Text and map changes proposed to the Proposed Submission City Centre Action Plan supported by Southampton City Council

1. Minor modifications (factual updates, corrections and minor changes for consistency and clarity) – in plan order

2. Main modifications (affecting the soundness of the plan, changing the approach and major changes) – in plan order

(Excerpt of revised map 18, Policies Map showing selected retail designations)

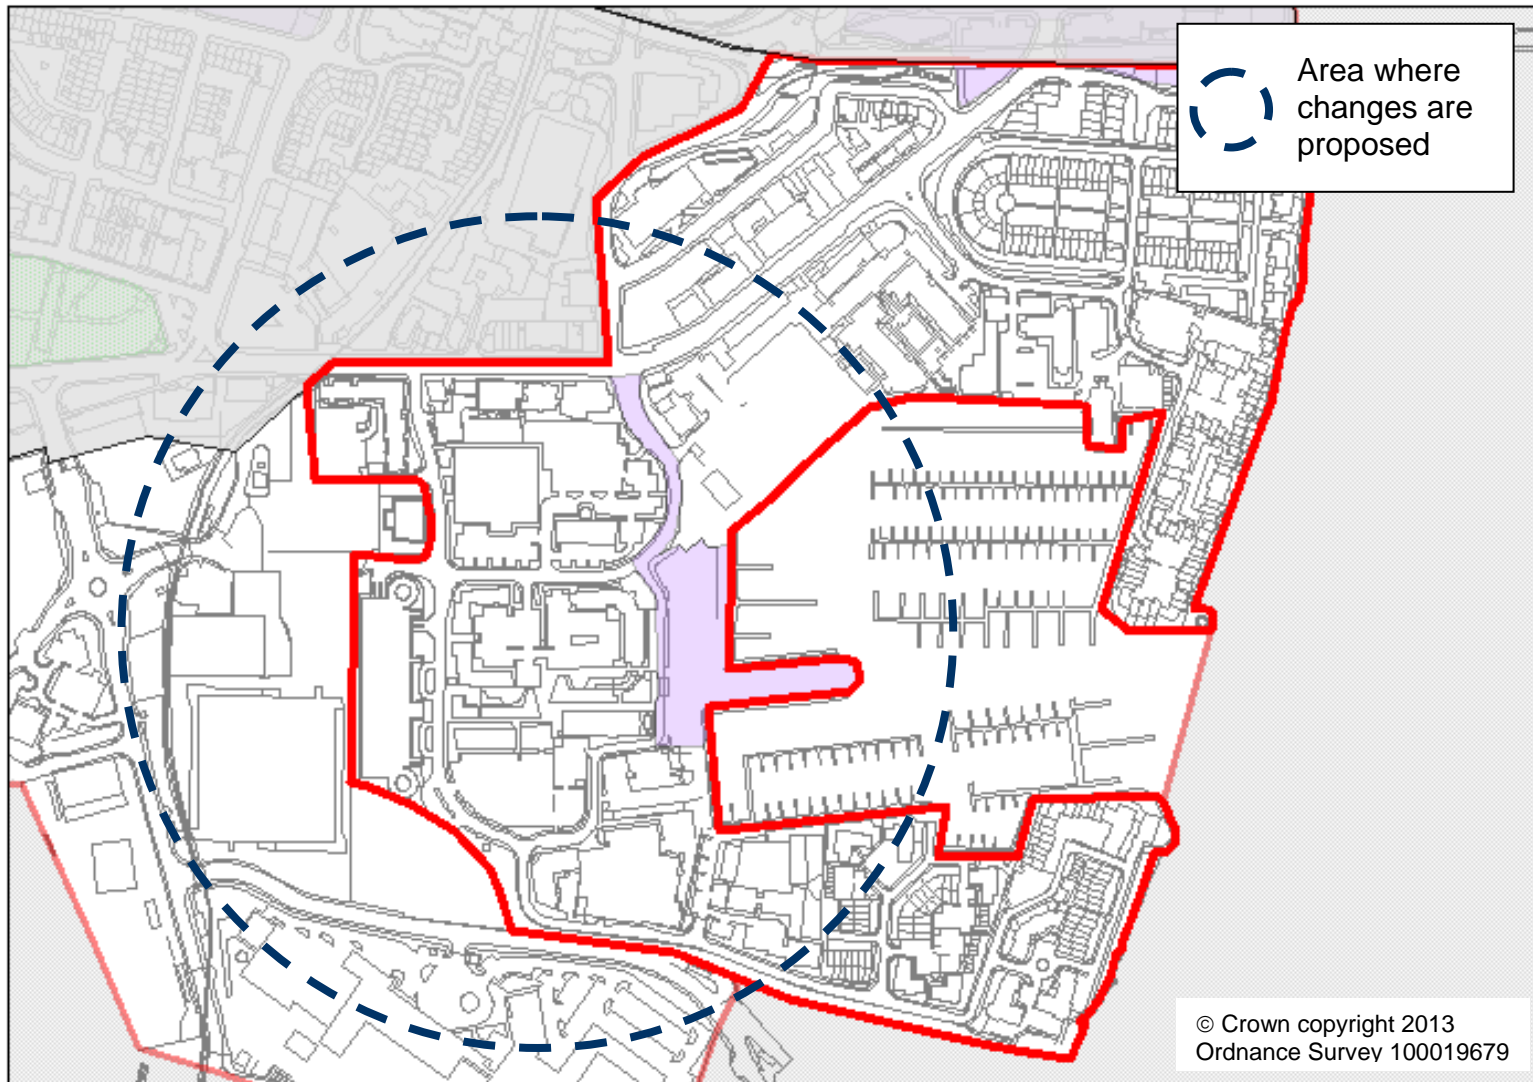
1. Extension of the Area of Search to include new area south of West Quay Retail Park (see main modifications for map 4 in the CCAP document and maps 18 & 20 in the Policies Map):

(Revised map 27, CCAP main document)

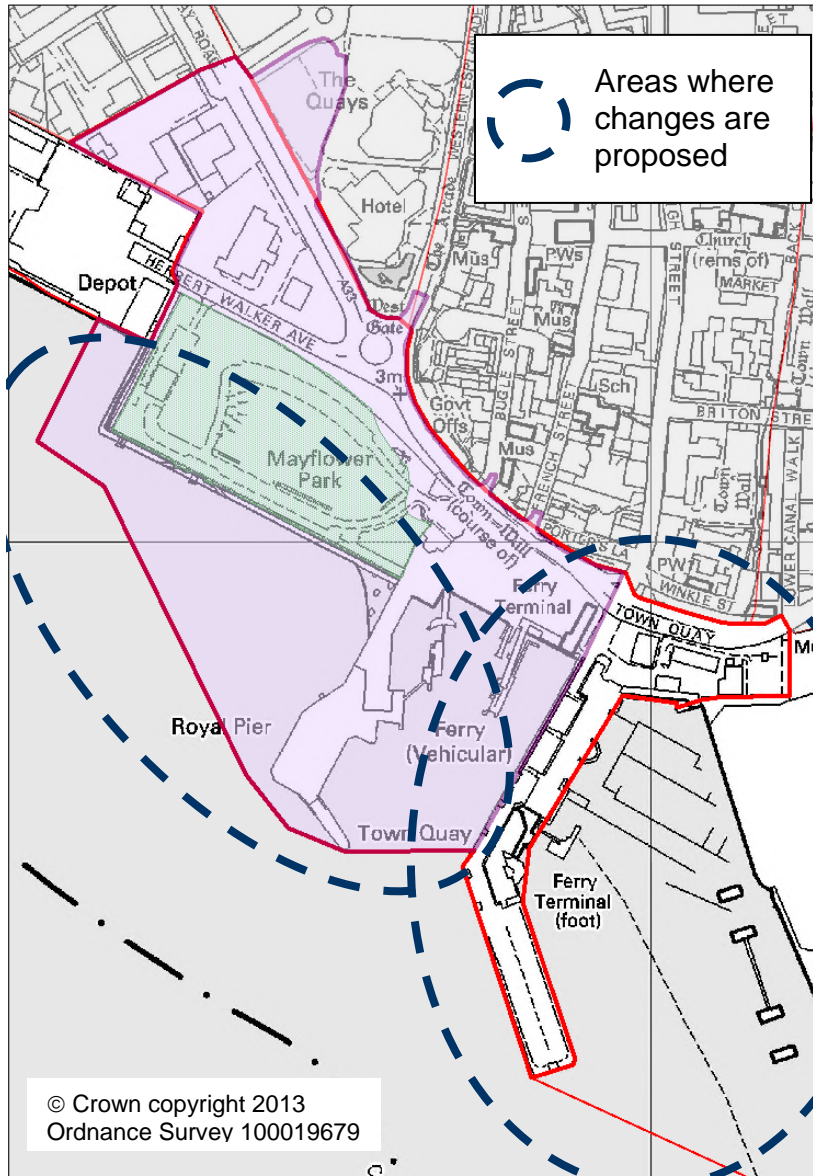
2. Amendments to Ocean Village quarter boundary and development site (see main modifications for map 15 in the CCAP document):

Around Marchwood Sea Mounting Centre:

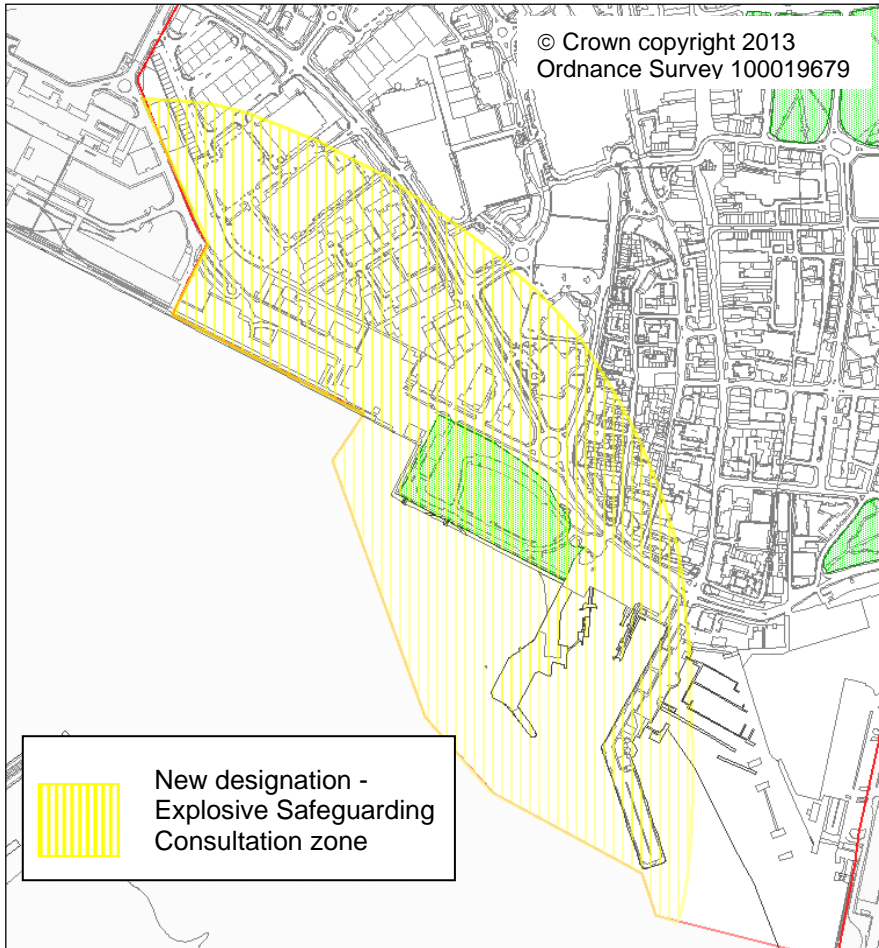
5. Add in Explosive Safeguarding zone (exact boundaries to be confirmed on Adoption) (see main modifications for maps 2 - 5 in the Policies Map):
